Form Title:	Document #:	
		ENGINEERING BULLETIN	EB-06-99 <small>(Form: DEF-003A-1)</small>
	Document Title:		Revision: 0
	Recommended Installation Procedure for 3" and 4" Wet-R-Dri Valves	Date: Sept. 10, 1999	
		Page: 1 of 1

Recommended Installation Procedure for 3" and 4" Wet-R-Dri Valves with 1-1/8" thick bodies.

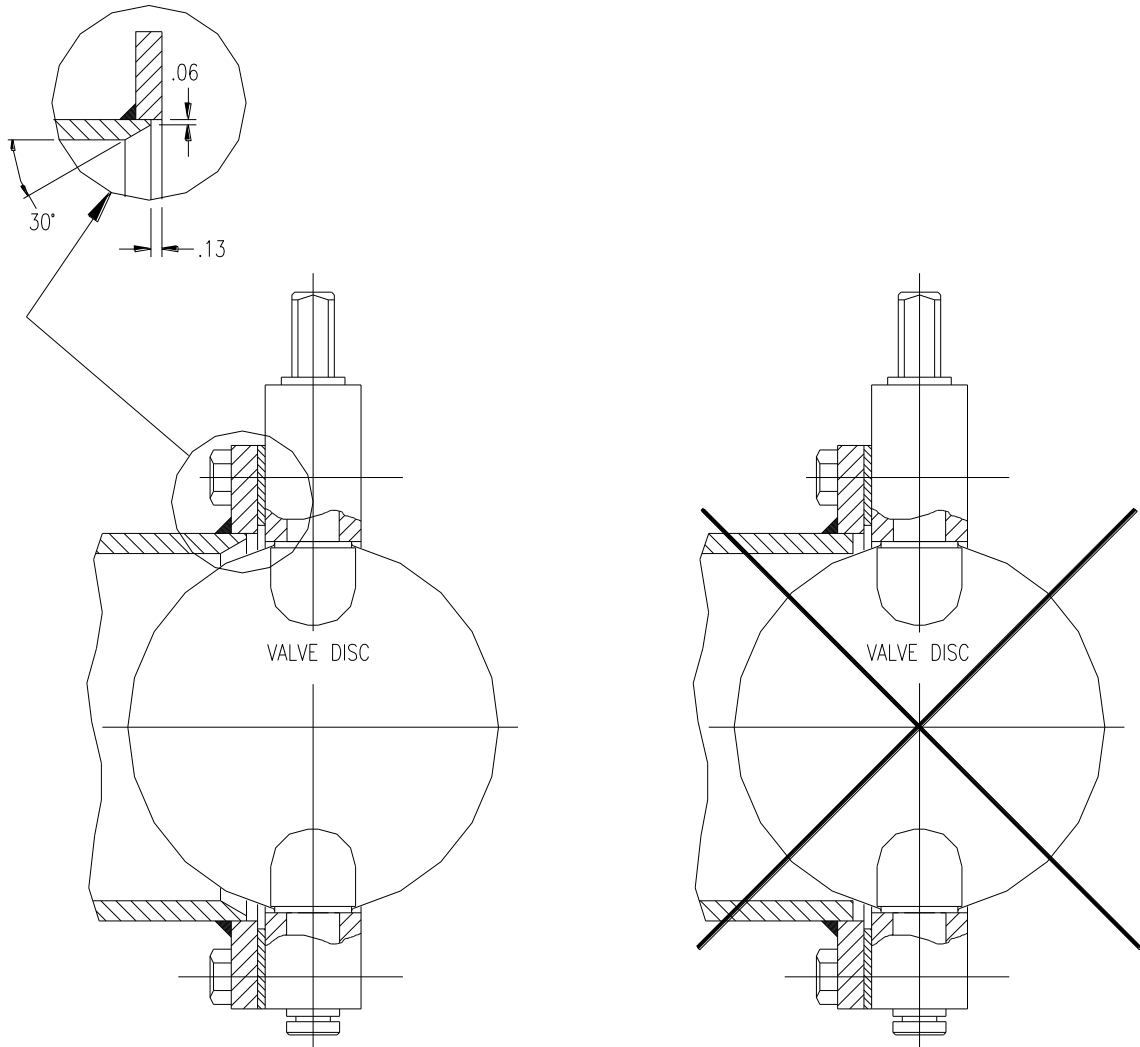
INCORRECT INSTALLATION
RUBBER COATING ON DISC MAY
BE CUT BY SHARP CORNER OF PIPE.

CORRECT INSTALLATION
CHAMFER ON PIPE I.D.
PROVIDES CLEARANCE FOR DISC.
